SERVICE INFORMATION NO. SI 42-038

MSB 42-039 Retrofit Breather Line
ATA-Code: 72-00

NO. MSB-42-039

„REDESIGN OF BREATHER LINE AND OIL SEPARATOR “

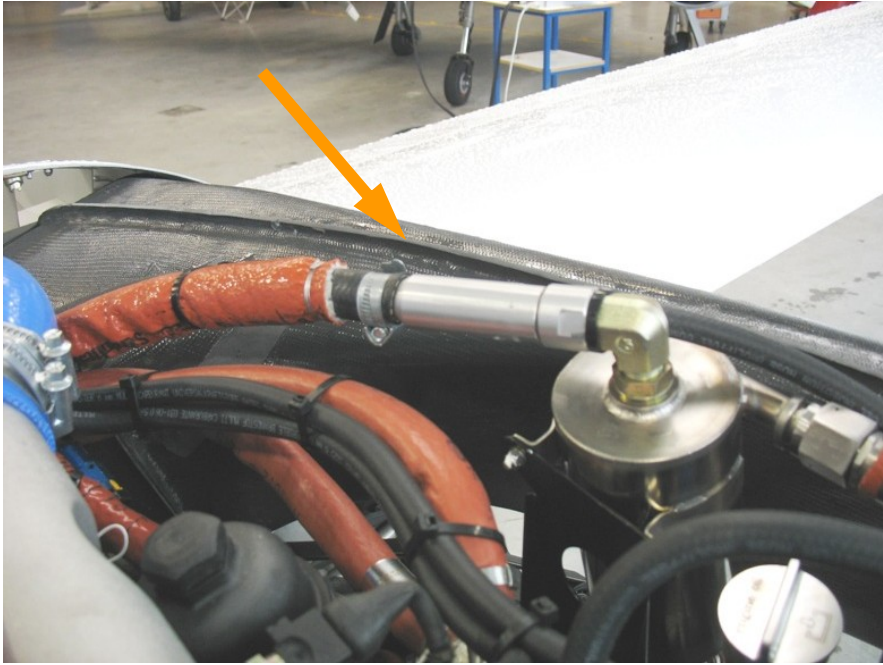
3	<p>Install new oil separator and new breather line according the following picture of this WI. Shorten breather line and fire sleeve as required and install breather line bypass (D60-7906-40-30 / D60-7906-40-31) acc. to picture.</p> 
4	Clean working area, check for foreign objects.
5	Check new installed items and all systems in working area for proper function.
6	Make appropriate entries into aircraft log.
